H. E. BOLTON, JR. SUBDIVISION

APPLICATION NUMBER 5 DATE November 3, 2005
APPLICANT H. E. Bolton, Jr. Subdivision
REQUEST Subdivision

H. E. BOLTON, JR. SUBDIVISION

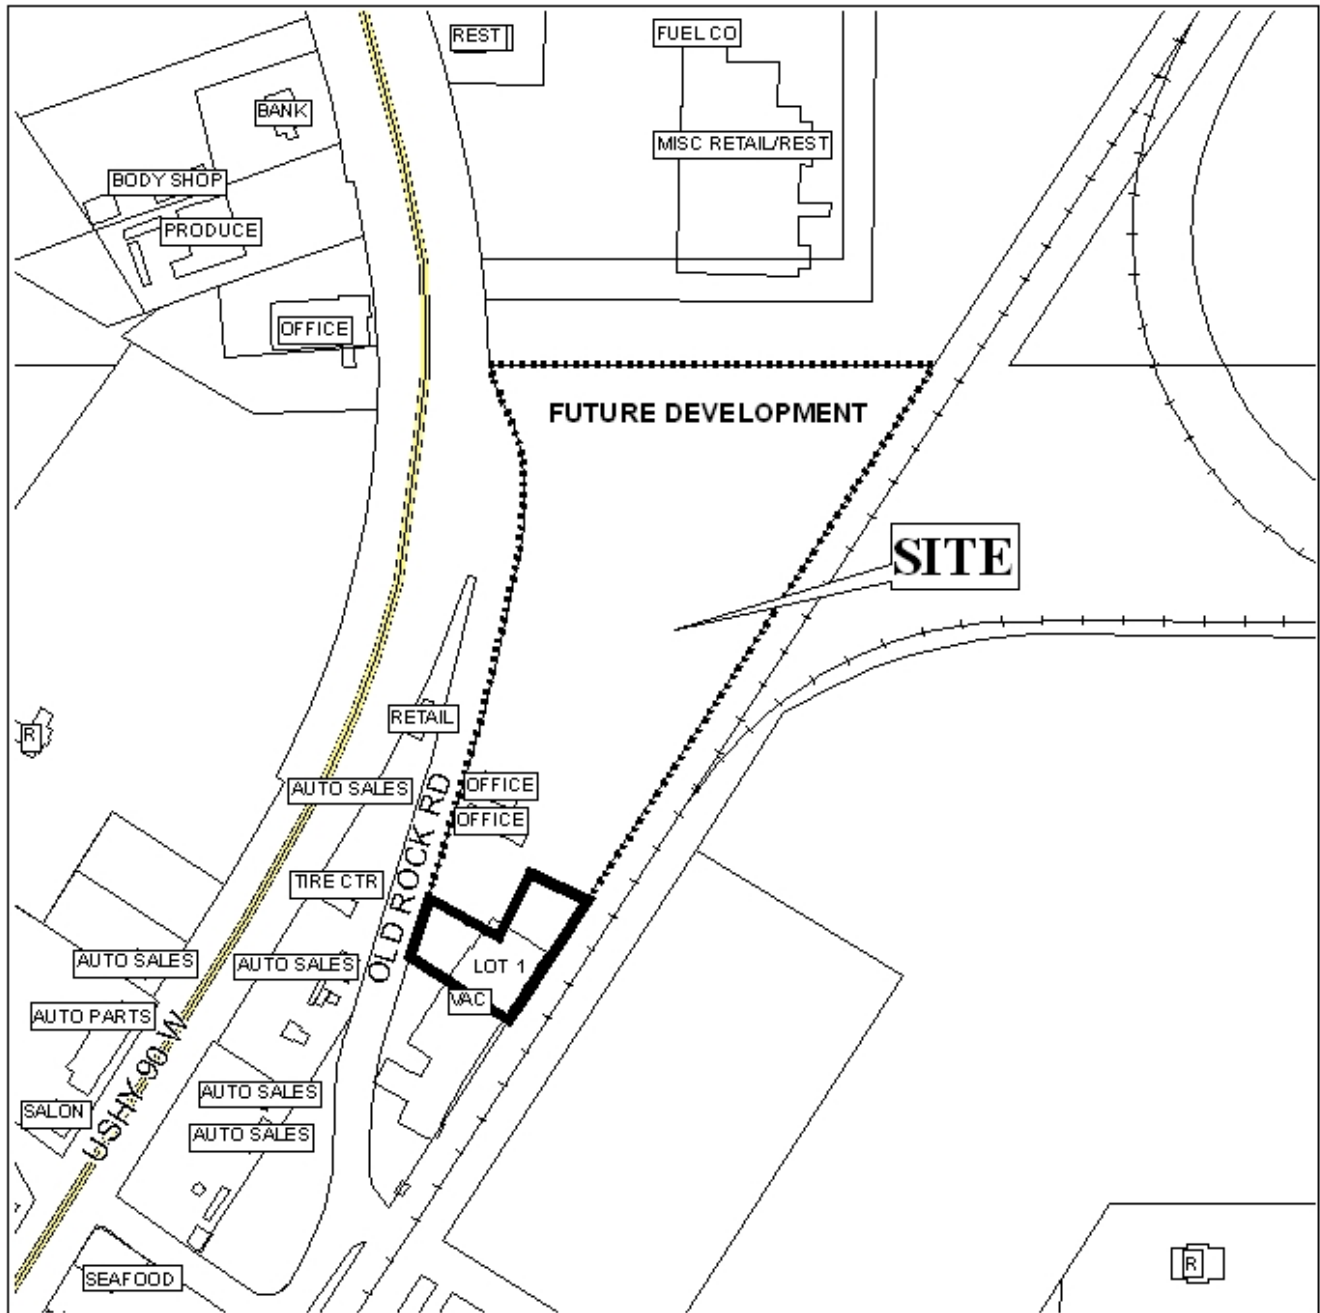
The 8.7 acre \pm site is partially developed: the proposed 32,000 square foot \pm Lot 1 will accommodate an existing warehouse/business building and parking area, while the remaining 7.98 acres \pm is labeled as "Reserved for Future Development." It should be noted, however, that a visit to the site indicates that some of the area "reserved for future development" is, in fact, developed with two commercial structures that are currently in use. Therefore, the plat should be revised to create at minimum a two-lot subdivision, encompassing the entire parcel, and the legal description on the plat should also be revised to reflect this change. The 25-foot minimum building setback line should also be depicted on the remainder of the parcel.

While Old Rock Road is a minor street, access management is a concern due to the large size of the parcel under consideration. The proposed Lot 1 should be limited to one curb cut, and the remainder of the parcel (the recommended Lot 2) should be limited to a maximum of four curb cuts, due to its 800 foot \pm frontage along Old Rock Road. The size, design and location of all curb cuts must be approved by the Mobile County Engineering Department.

This site is located in Mobile County, thus a note should be placed on the Final Plat stating that any lots which are developed commercially and adjoin residentially developed property must provide a buffer, in compliance with Section V.A.7. of the Subdivision Regulations.

Based upon the preceding, the plat is recommended for Holdover for the following reasons: 1) the revision of the plat and legal description to create at minimum a two-lot subdivision; 2) provision of labels and postage for notification of adjacent property owners located on parcels R023802032000015.01 and R023802032000013.
